**FINAL DRAINAGE REPORT
FOR
ELDORADO SPRINGS
PPR-19-032**

November 5, 2019
Revised February 5, 2020

WestWorks Job #91807

Detention Basin Outlet Structure Design

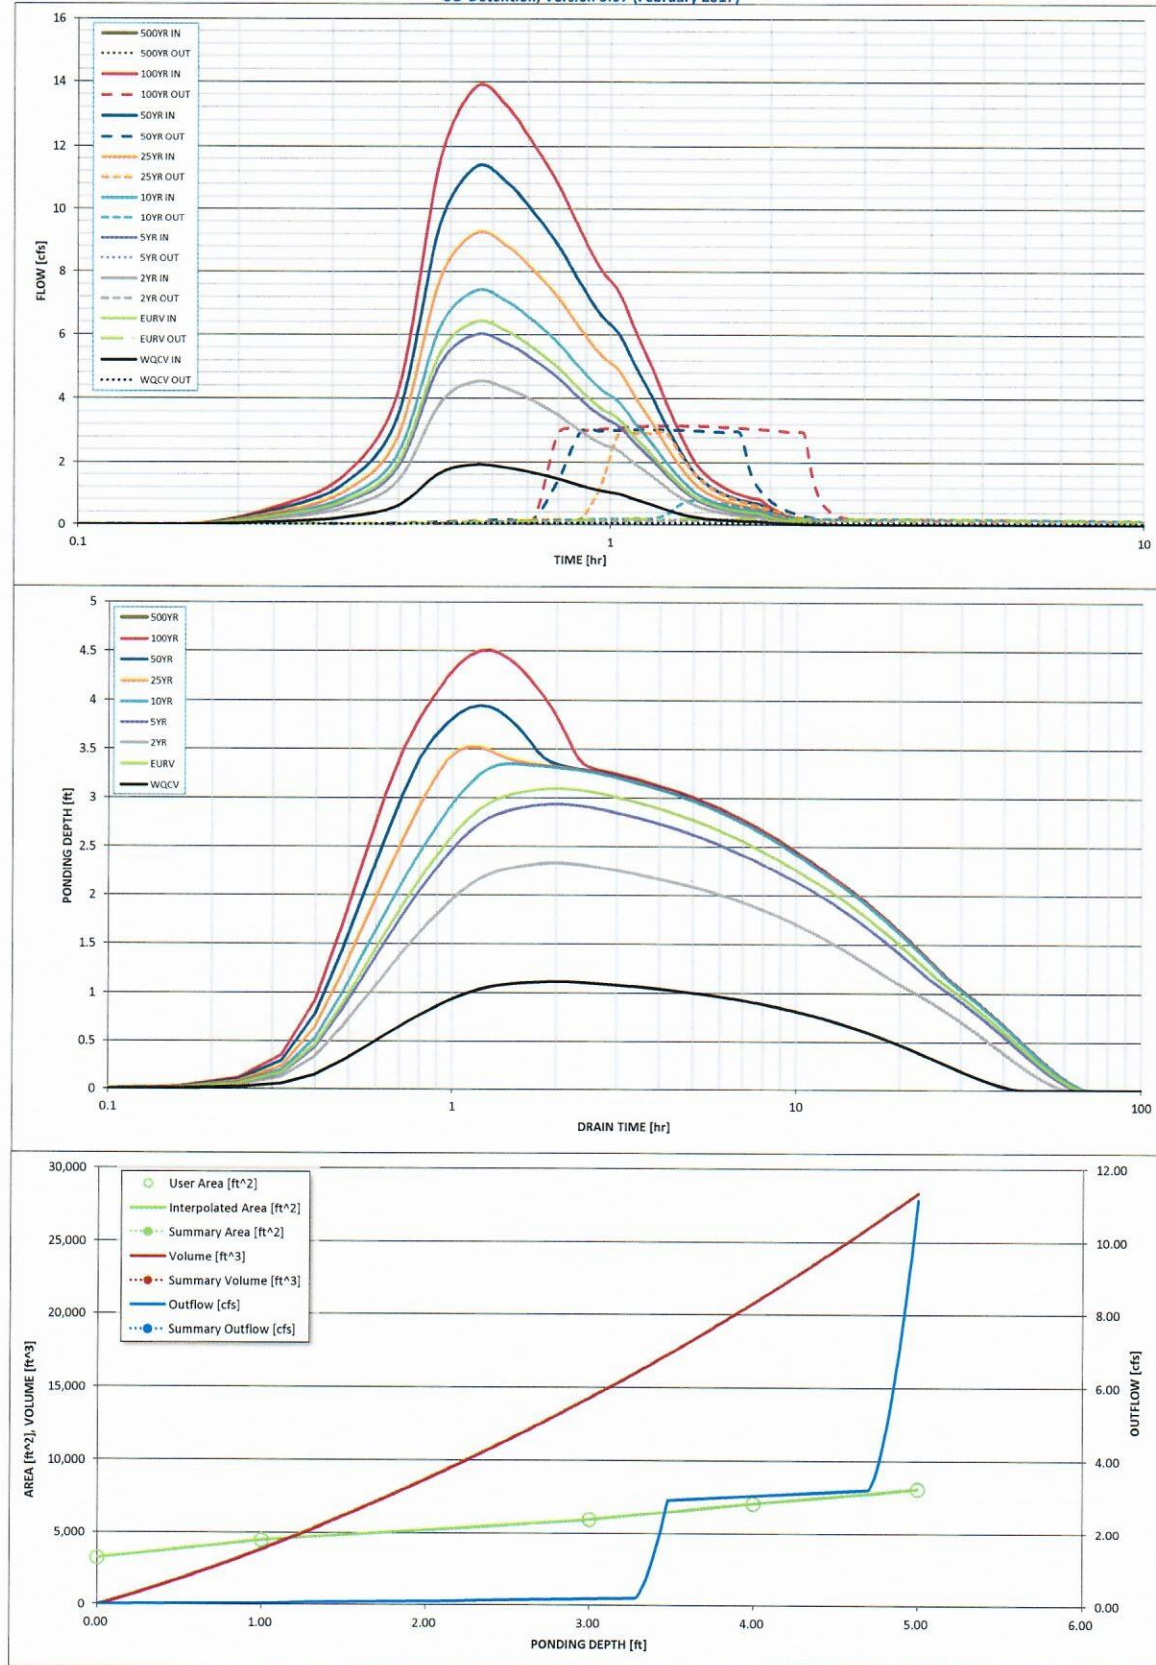
Revise design. For full spectrum design, these ratio must be equal to or less than 1.0.

Detention Basin Outlet Structure Design

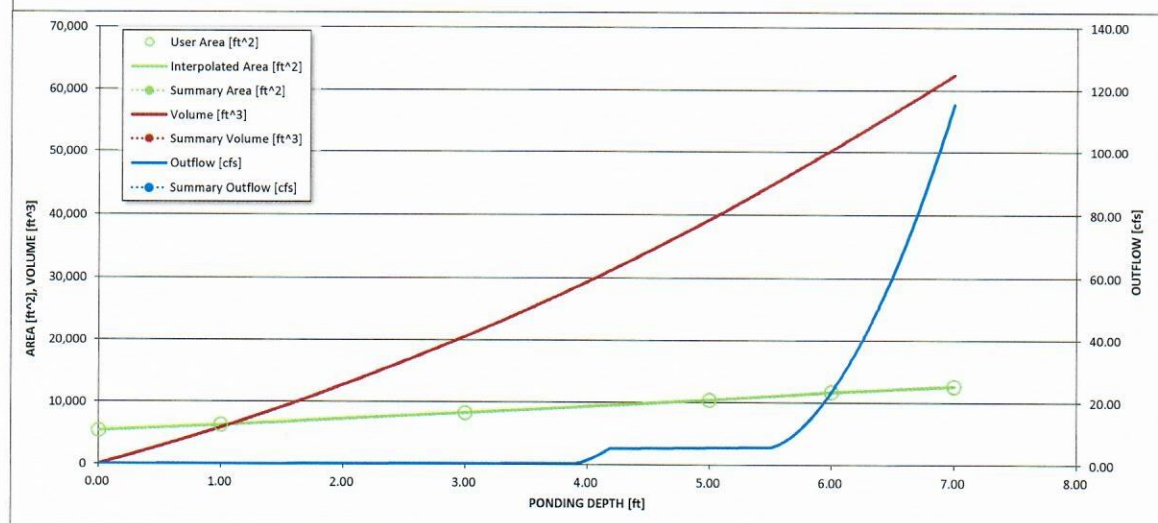
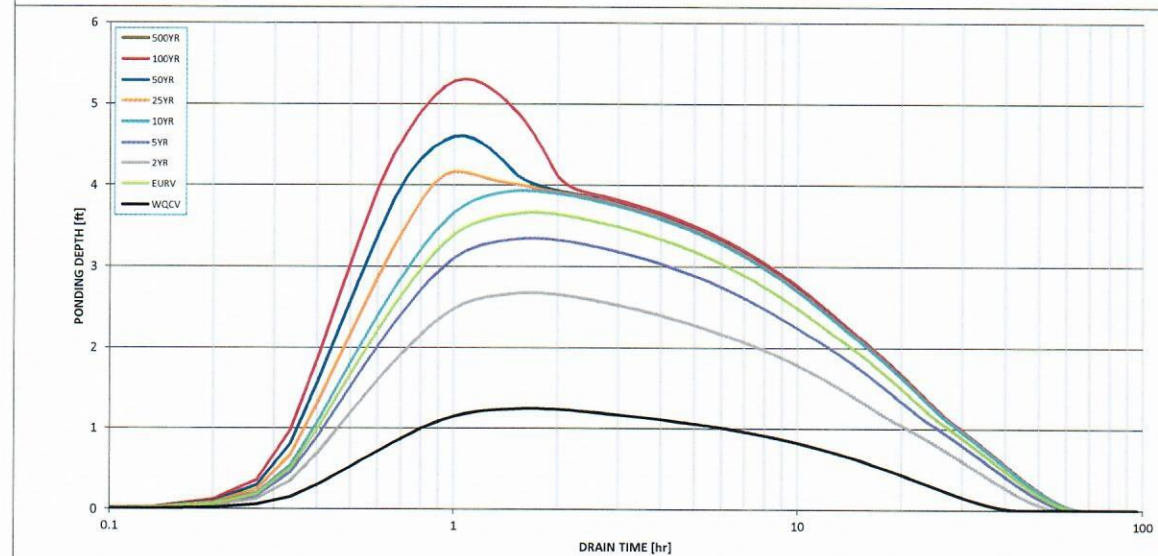
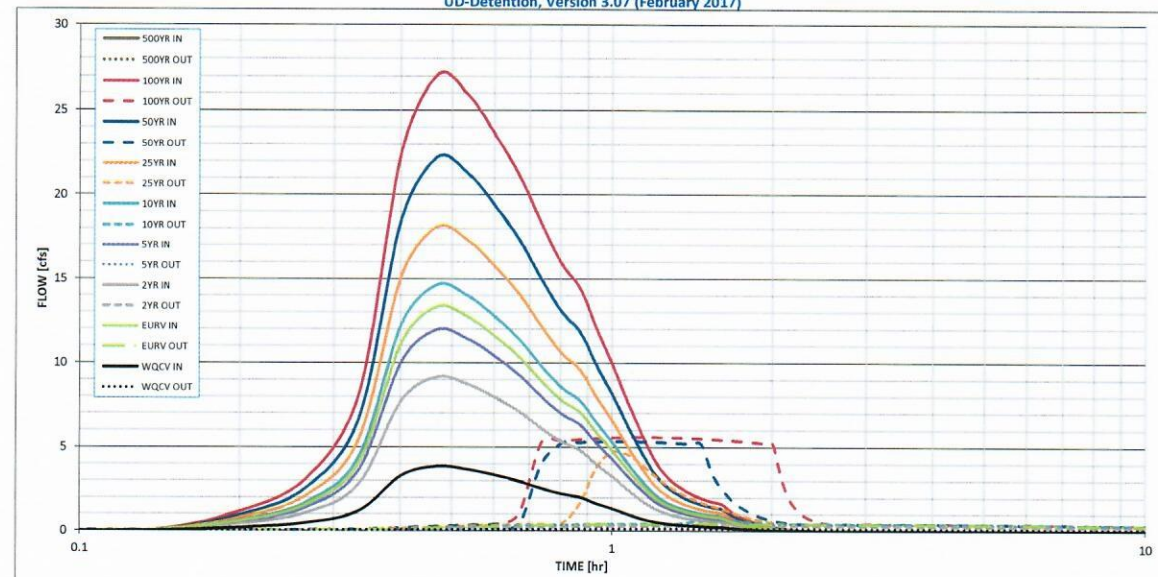
Revise design. For full spectrum design, these ratio must be equal to or less than 1.0.
